BD3A BLOCK DIAGRAM

PROJECT : BD3A
Quanta Computer Inc.

Size	Document Number TURION 64 CTRL & DEBUG	Rev 3C
Date:	Tuesday, January 22, 2008	Sheet 6 of 43

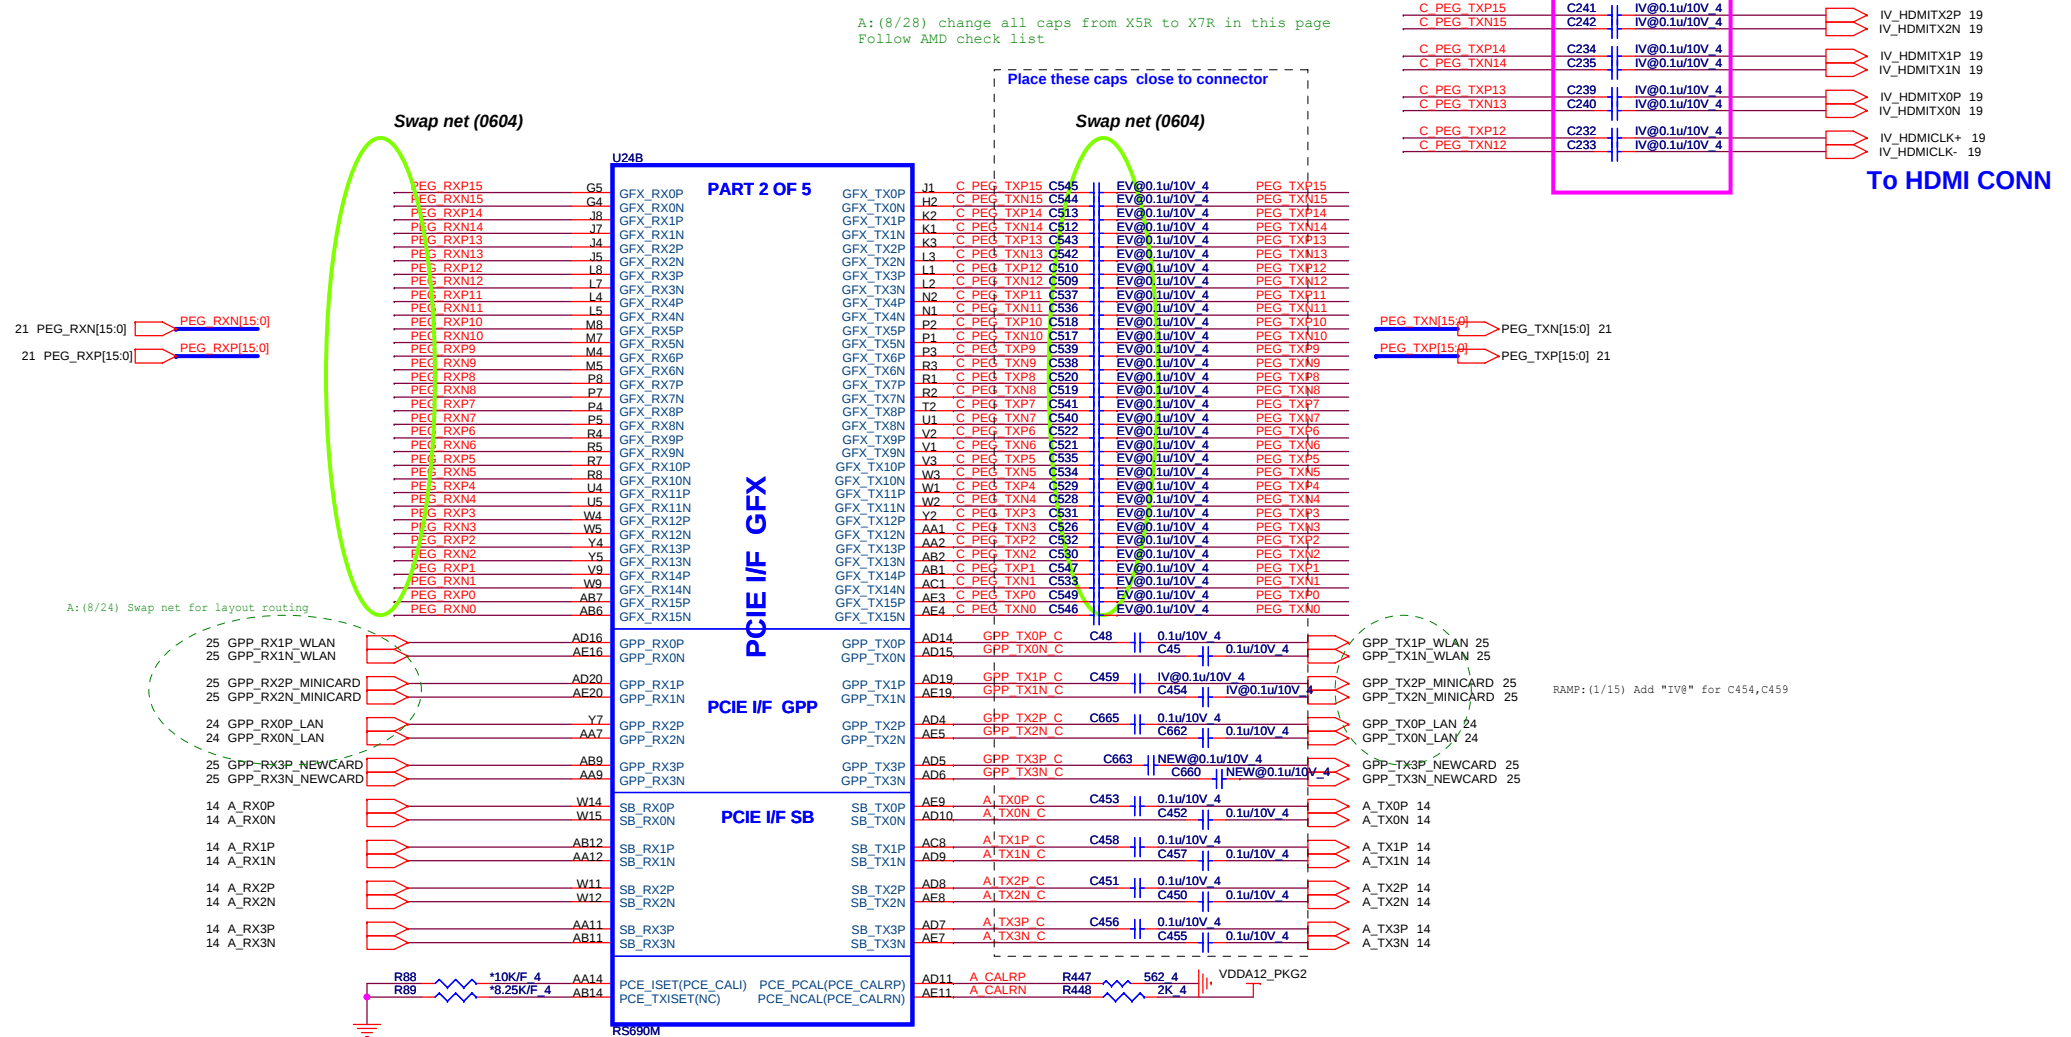
A:(8/27) Please put the CAP between +1.8VSUS & +SMDDR_VTERM

SB600 SB 23x23mm

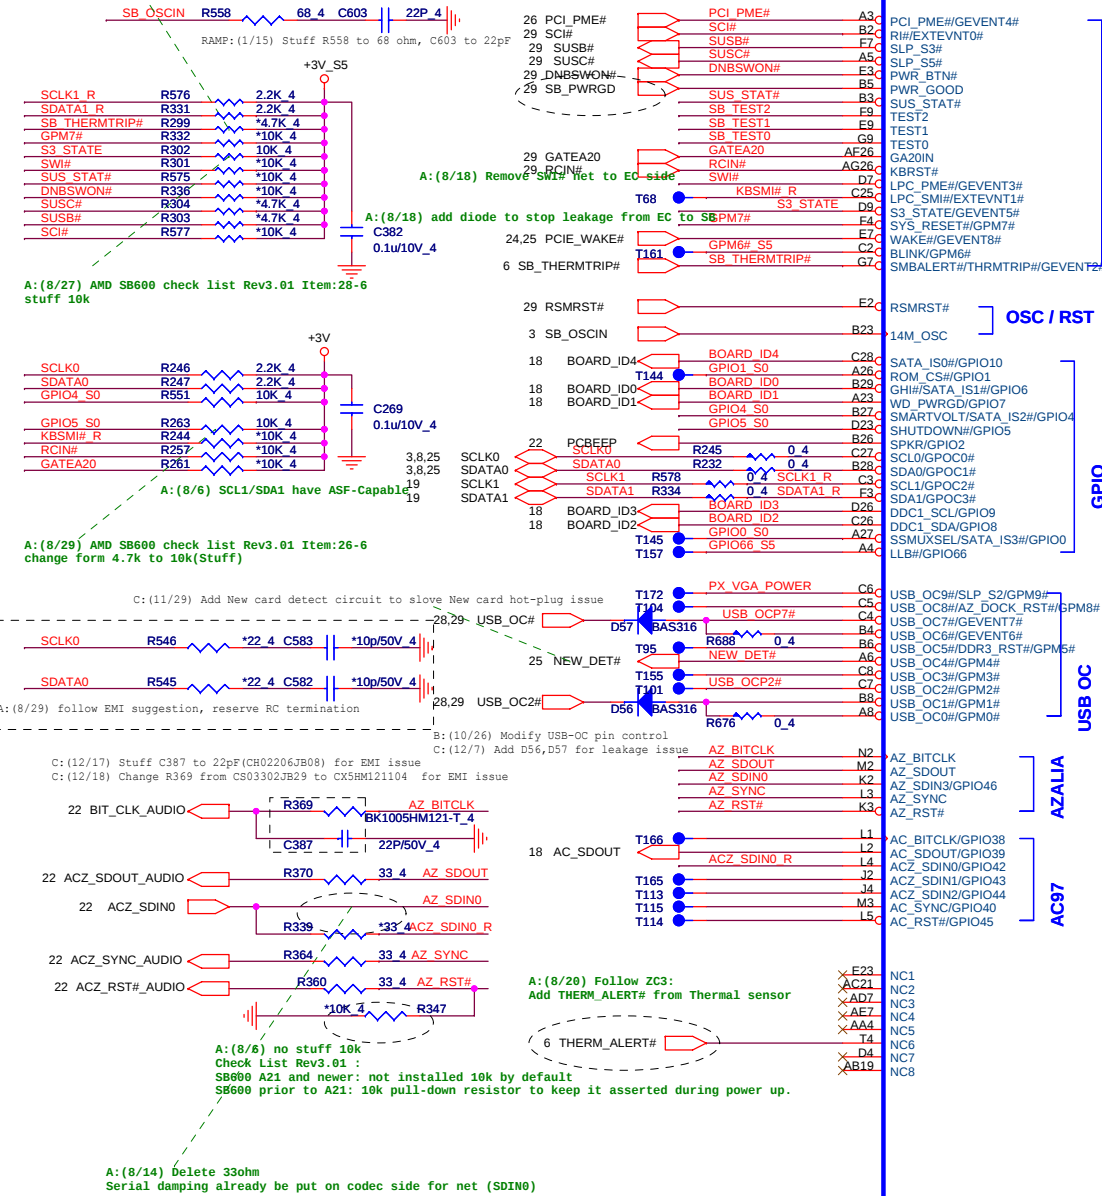
A:(8/27) no stuff 4.7k
AMD SB600 check list Rev3.01 Item:24-17
SB600 have internal PU resistor

A:(8/14) change net name from SBPWROK to ECPWROK

SB600 SB 23x23mm
Part 2 of 4

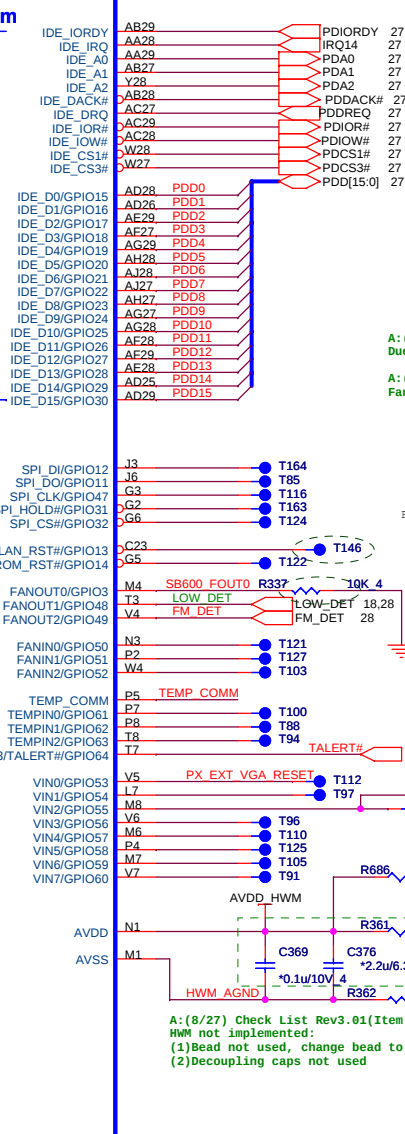
A: (8/28) Follow AMD check list Item1-38:
Change from 0.1u to 1u

A: (8/14) Remove LAN_RST net. Reserve a test point.
Due to LAN_RST net already be deleted in LAN side.

A: (8/6) Check List Rev3.01:
Fan Control Not Implemented: Used as GPIO3 or terminated

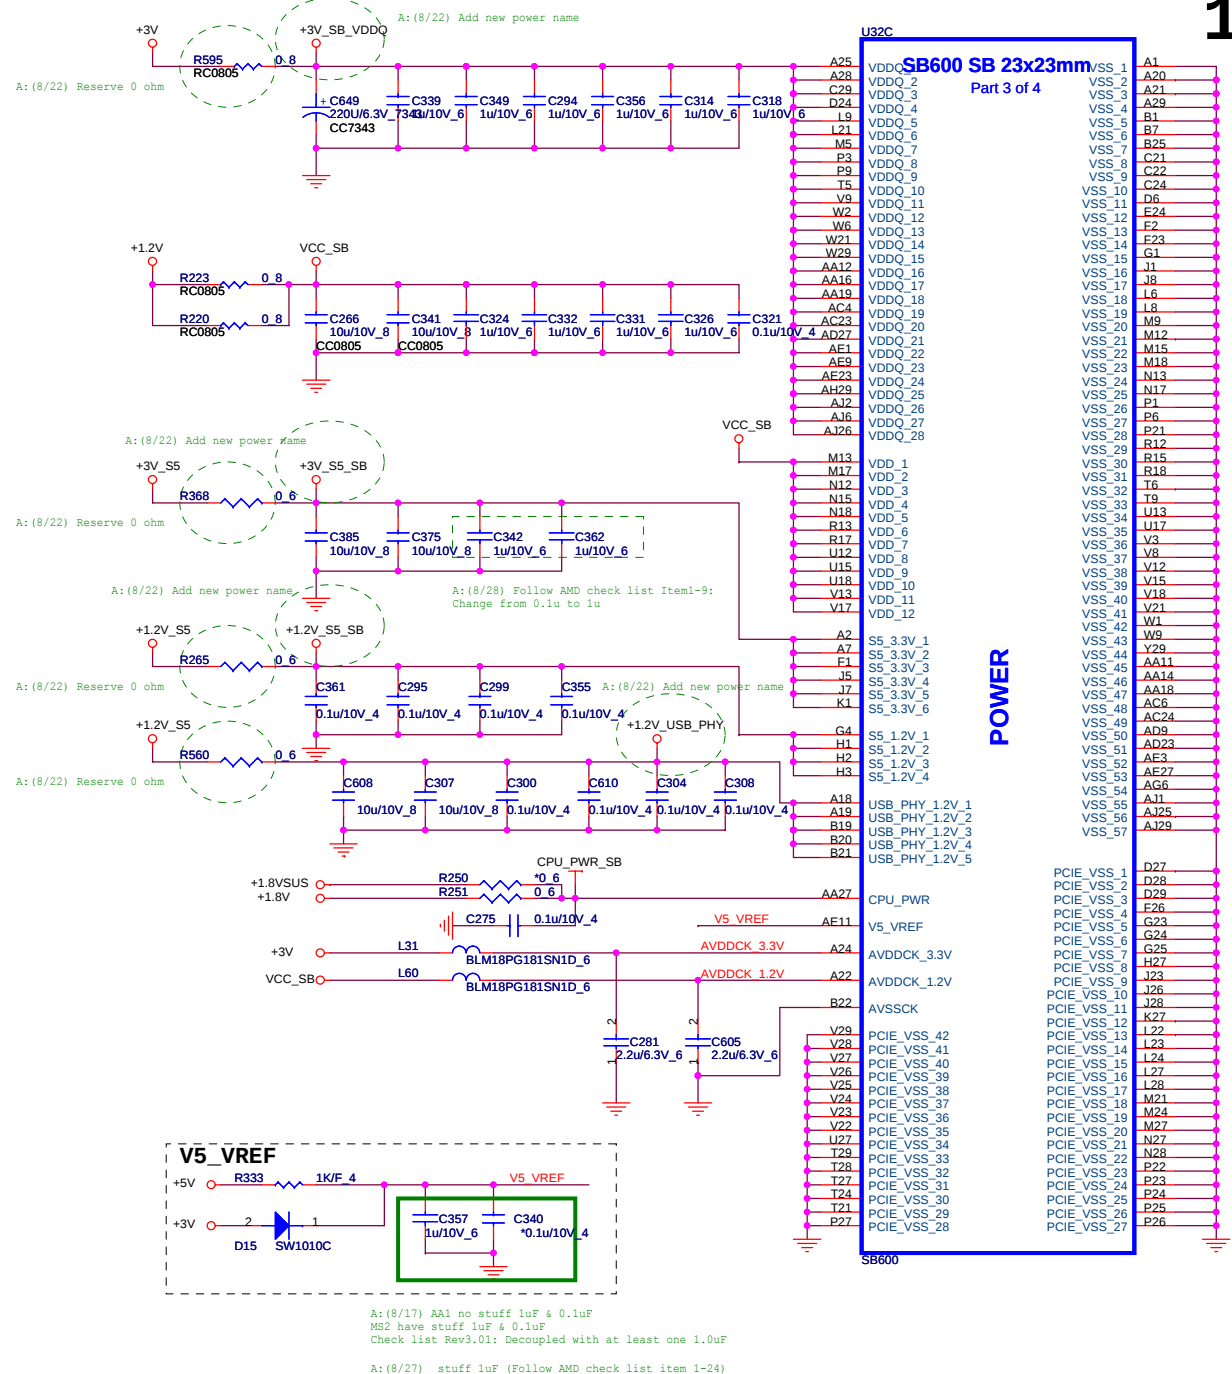
B: (10/18) add FM_DET to GPIO48
B: (10/25) add R673 (no stuff) for debug use

A: (8/27) Check List Rev3.01: 22-11
Let TEMP_COMM connect to GND
when Temp Monitor not implementing

A: (8/6) Check List Rev3.01: Tie to a +3V_S5 rail
Change AVDD from +3V to +3V_S5 (MS2/AA1: +3V for A-test)

B: (10/26) Add R686 to +3V, no stuff R361 for leakage issue

A: (8/27) Check List Rev3.01 (Item 1-33, 1-34):
HWM not implemented:
(1) Bead not used, change bead to 0 ohm (no stuff)
(2) Decoupling caps not used

A: (8/17) AA1 no stuff 1uF & 0.1uF
MS2 have stuff 1uF & 0.1uF
Check list Rev3.01: Decoupled with at least one 1.0uF

A: (8/27) stuff 1uF (Follow AMD check list item 1-24)

Board ID	ID4	ID3	ID2	ID1	ID0
NEW CARD					H
CARD BUS					L
CCFL Panel				H	
LCD Panel				L	
W/ MXM					
W/O MXM				H	
W/ S-VIDEO				L	
W/O S-VIDEO					
W/ HDMI					
W/O HDMI	H

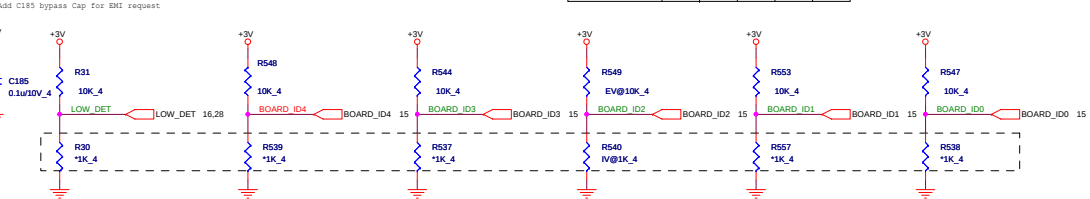
C: (11/29) Board ID issue!
(1) Because GPIO pin of South Bridge have internal PU or PD. It will let Board ID become floating (+1.5V) when external circuit PD
(2) Change external Pull down to 1K ohm for all BOARD_ID and LOW_DET circuit

B: (10/30) GPIO8 (BOARD ID2) for UGA/MXM detection use
(1) Stiff R540 (pull low), don't stuff R549 for UGA
(2) Stiff R549 (pull high), don't stuff R540 for MXM

CRT PORT

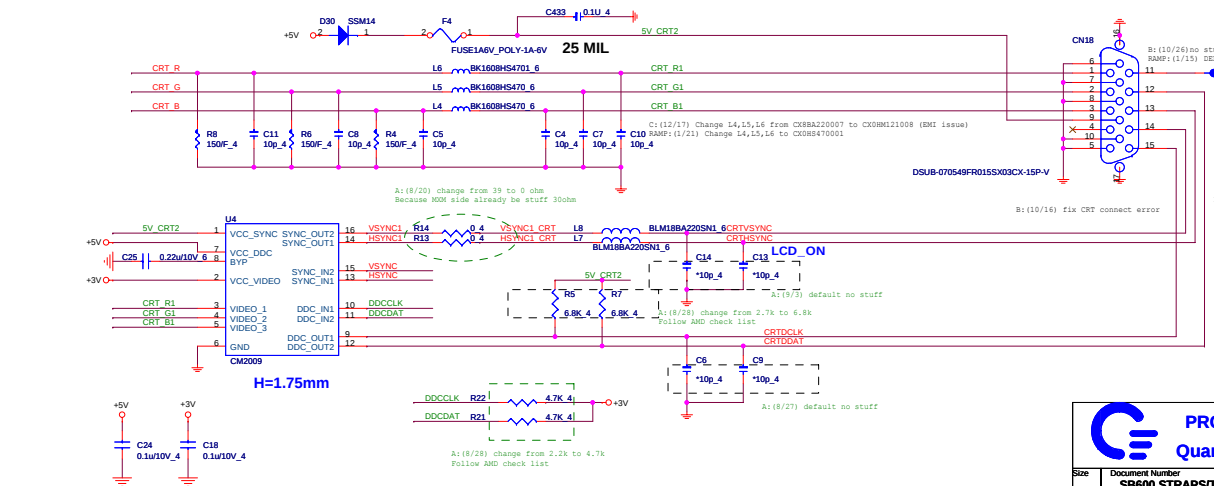
B: (10/26) no stuff D4 for CRT CONN CN18/Pin11 (NO1 request)
RAMP: (1/15) DEL D4, D5 footprint and DEL NET CRT_SENSE#

A: (8/20) Reserve Diode for ESD solution

B: (11/11) Change CN18 P/N to DPM015PR048 (Follow BL38 & ME)

SATA HDD

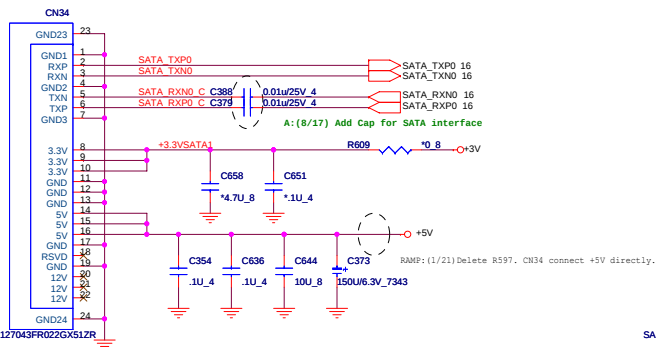
RAMP: (1/21) ADD D91, D92 (0603 Varistor) for two SATA CONN (CN32&CN34) +5V power pin

RAMP: (1/20) ADD D83-90 for two SATA CONN (E3D issue)
